Currently Bidding Phase II Work Only

GRADING PLAN	
ACCUSHARP DEVELOPMENT PLAT (PROJECT IN CEDAR PARK ETJ.)	
CASE: DP-18-001	SHEET
DATE: Oct 05, 2020	9
DRAWN BY: GEJ	OF 25
DESIGNED BY: GEJ	
REVIEWED BY: GEJ

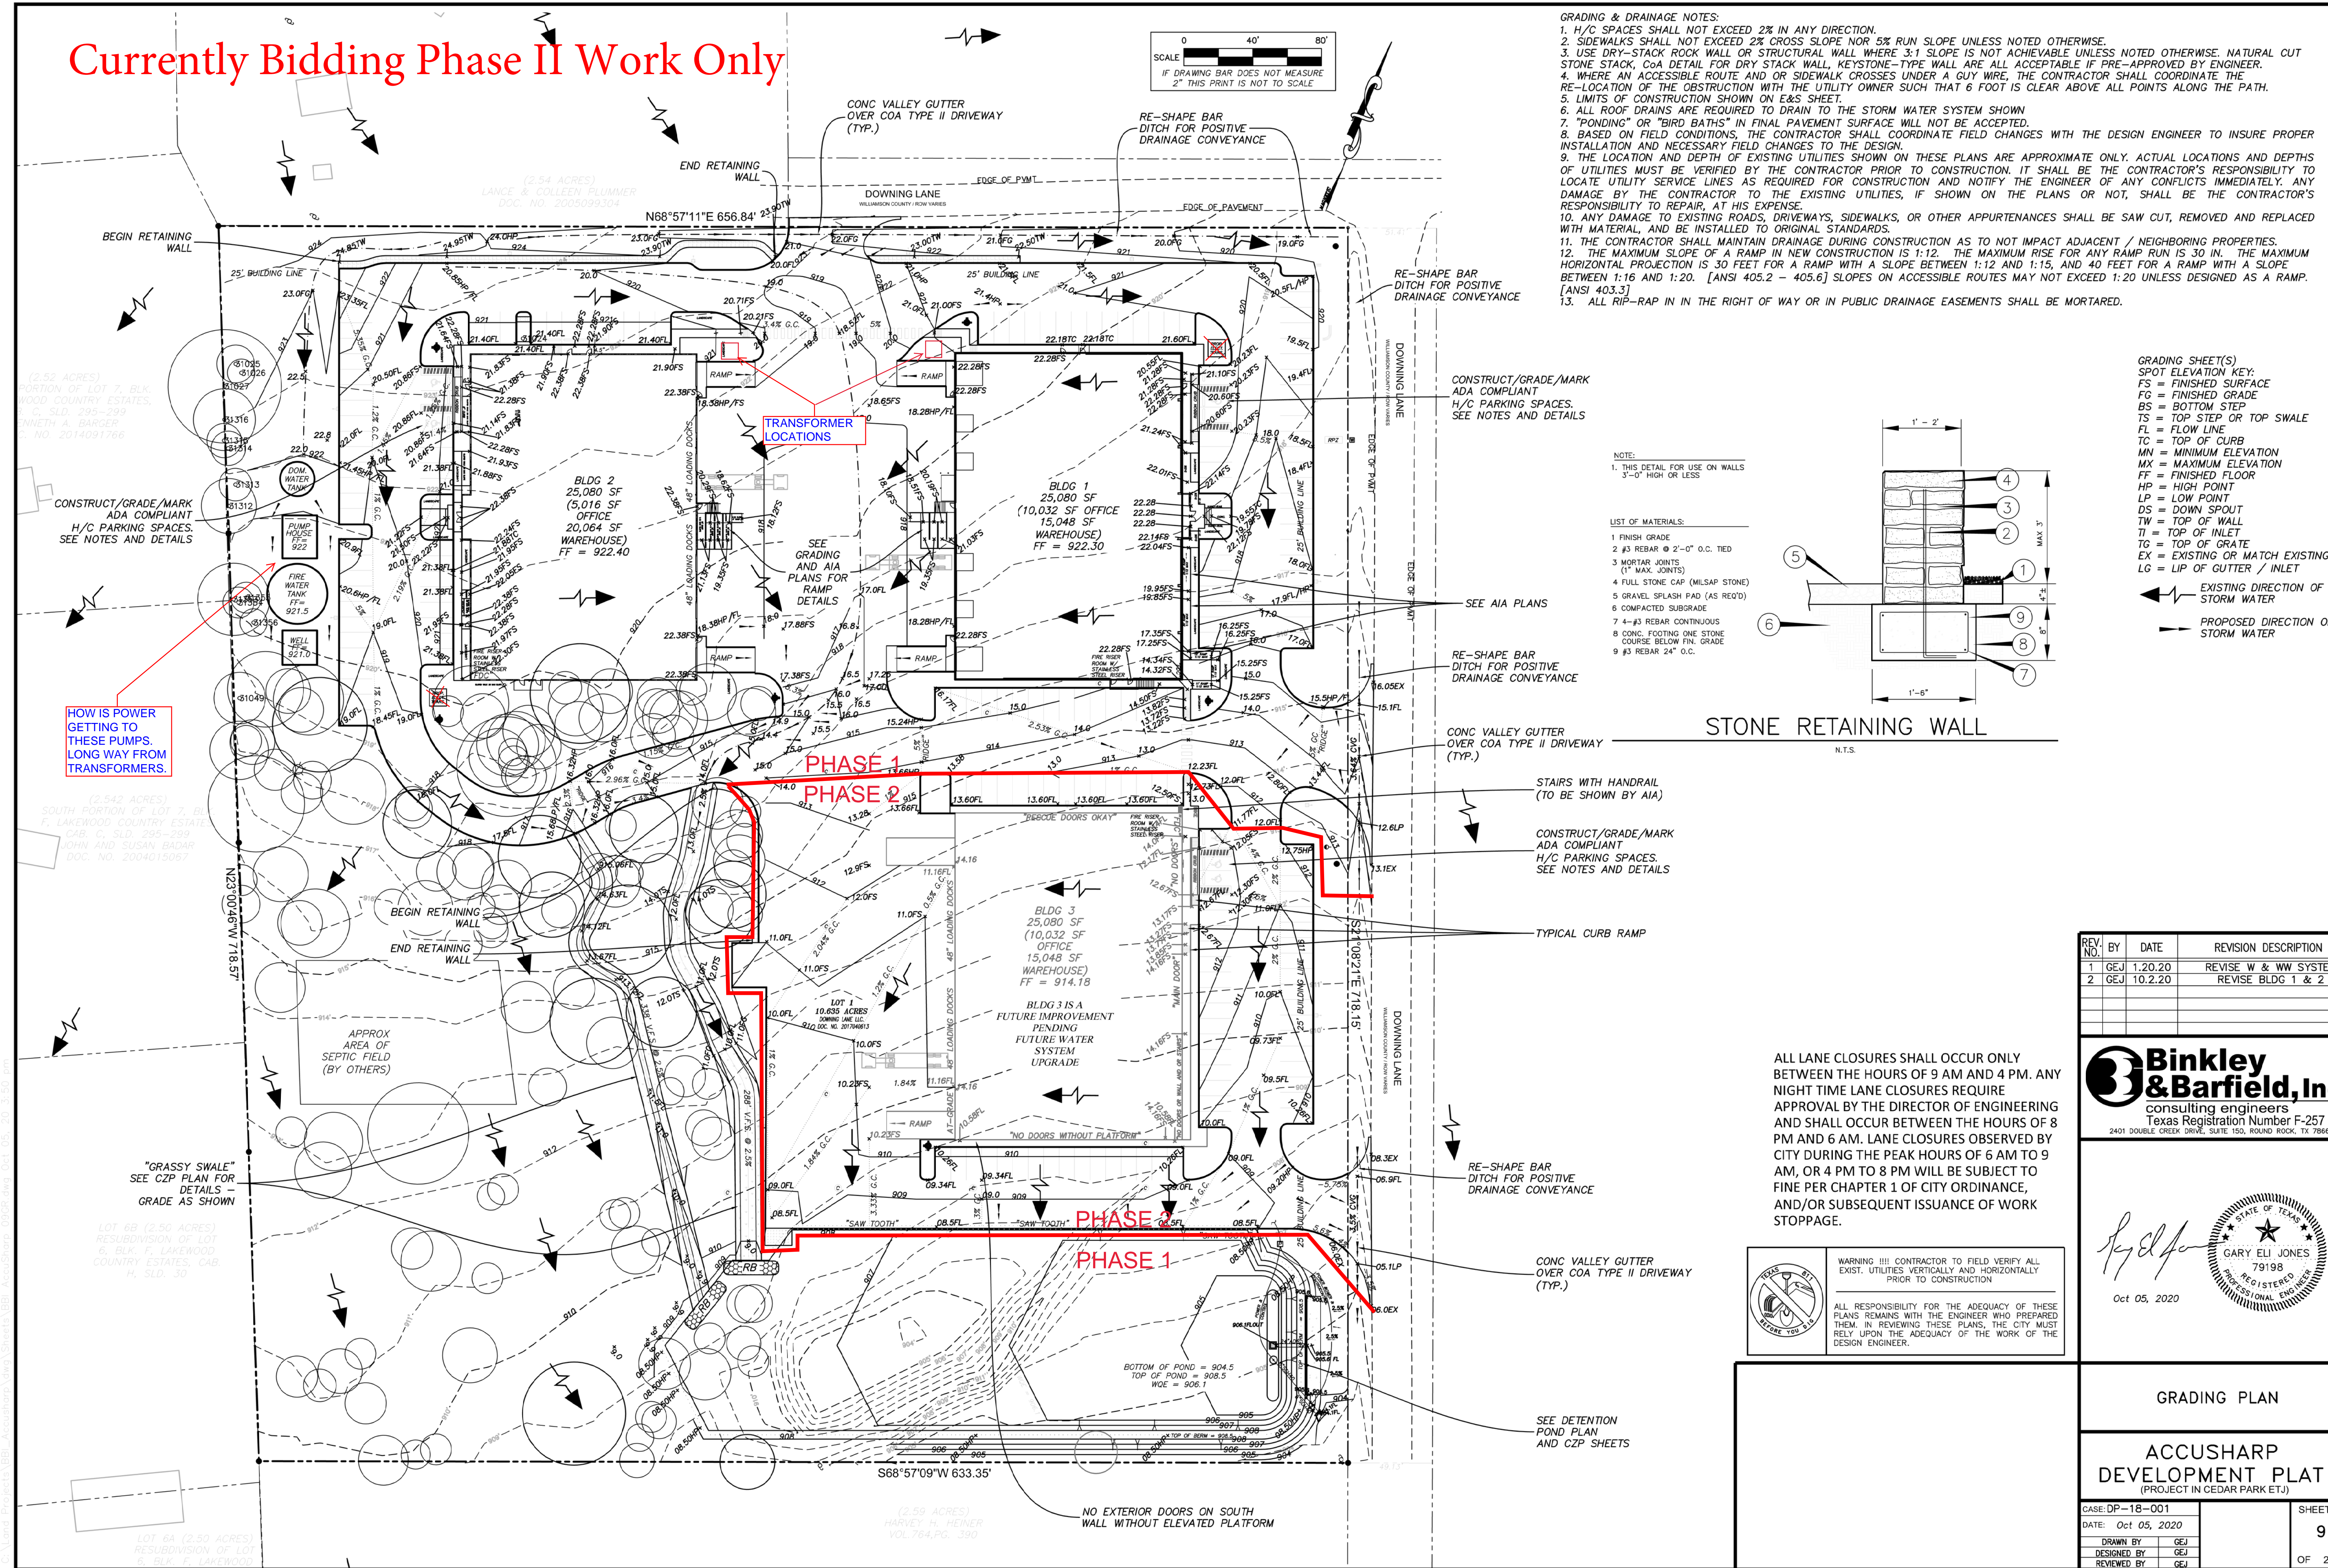
HOW IS POWER GETTING TO THESE PUMPS. LONG WAY FROM TRANSFORMERS.
